TE Connectivity

Product Change Notification: E-15-007872

OJ product family

compare draft

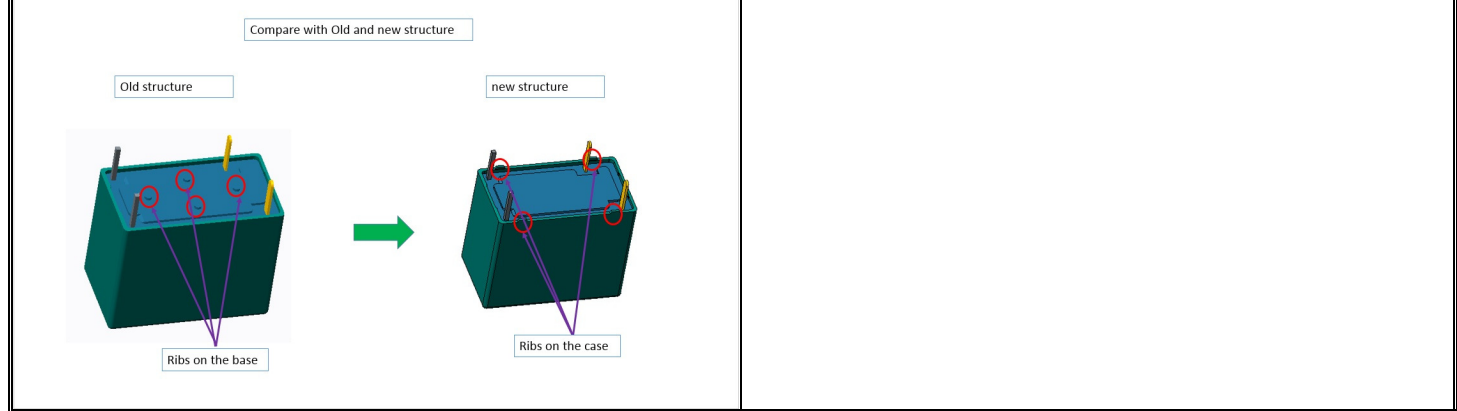
remove the ribs on the base to case

Product Improvement. for better reliability of the relay when Mounting. No datasheet or performance change
